Location: 133 Eaton Square

Proposal:

• Subdivision approval to create one (1) legal lot of record from one (1) legal lot of record.

CHATEAU NOBLET SUBDIVISION

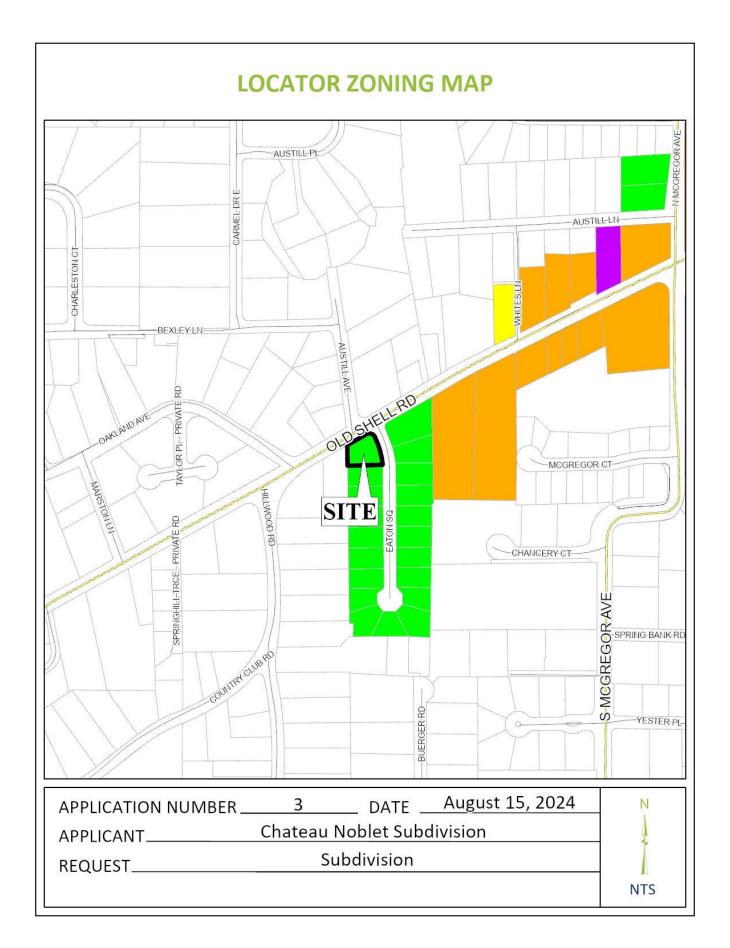
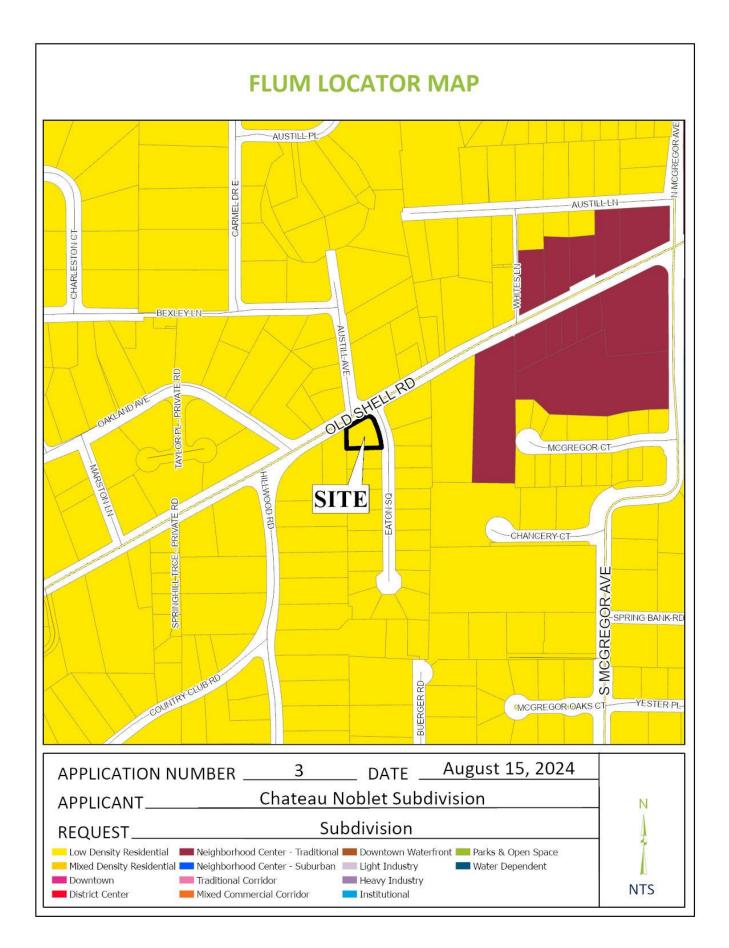
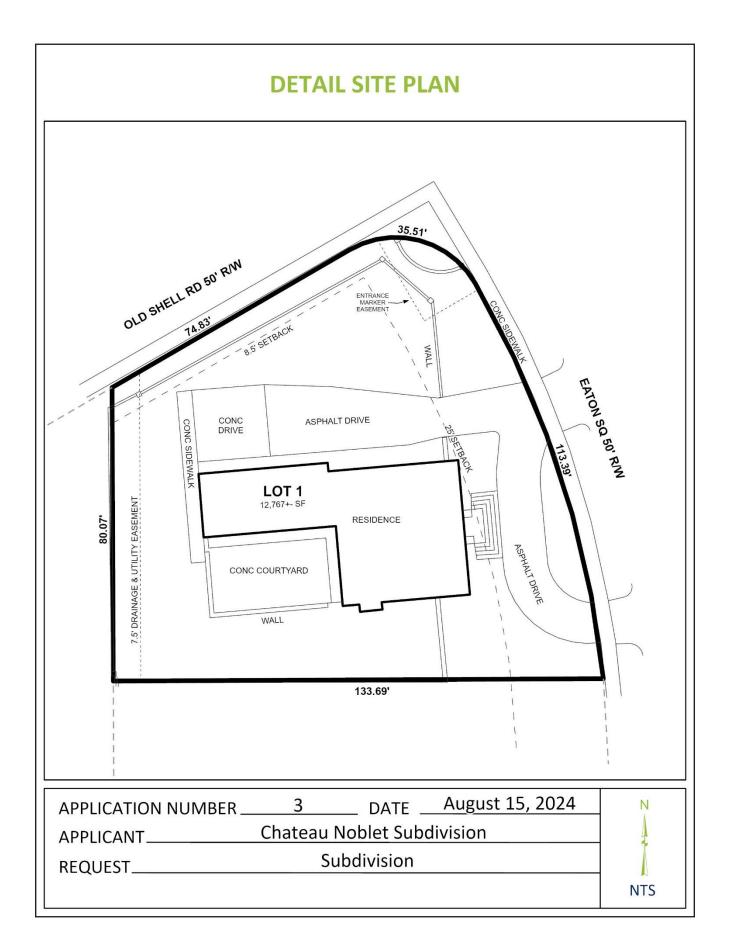
- Provide all of the required information on the SUBDIVISION PLAT (i.e. signature blocks, signatures, certification statements, written legal description, required notes, legend, scale, bearings and distances) that is required by the current Alabama State Board of Licensure for Professional Engineers and Land Surveyors.

- B. Provide a signature line for the Surveyor's Certificate.
- C. Add a note to the SUBDIVISION PLAT stating that as shown on the 1984 aerial photo (FLIGHT 23 #72) LOT 1 will receive historical credit of existing (1984) impervious area towards stormwater detention requirement per Mobile City Code, Chapter 17, <u>Storm Water Management and Flood Control</u>) as follows: LOT 1 – NONE.

The preliminary plat indicates that both Old Shell Road and Eaton Square have compliant 50-foot rights-of-way; therefore, no dedication would be required. However, the applicant should verify the right-of-way width of Old Shell Road as other plats within the area depict a right-of-way width of 60 feet. A compliant 25-foot radius curve was recorded at the intersection of Old Shell Road and Eaton Square. The right-of-way widths of both streets should be retained on the Final Plat, if approved.

The proposed lot exceeds the minimum size requirement of the Subdivision Regulations, and the lot size label in both square feet and acres should be retained on the Final Plat, if approved, or a table should be furnished on the Final Plat providing the same information.

The site contains a recorded drainage and utility easement along the West (rear) of the property. Thus, the note on the preliminary plat stating that no structure shall be constructed or placed within any easement without the easement holder's permission should be retained on the Final Plat, if approved.

- 1. Retention of the right-of-way widths of Old Shell Road (to be verified if 50 feet or 60 feet) and Eaton Square on the Final Plat;
- 2. Retention of the lot size label in both square feet and acres on the Final Plat, or the furnishing of a table on the Final Plat providing the same information;

- 3. Retention of the setbacks along Eaton Square and Old Shell Road, as depicted on the preliminary plat;
- 4. Retention of the note on the Final Plat stating that no structure shall be constructed or placed within any easement without the easement holder's permission;
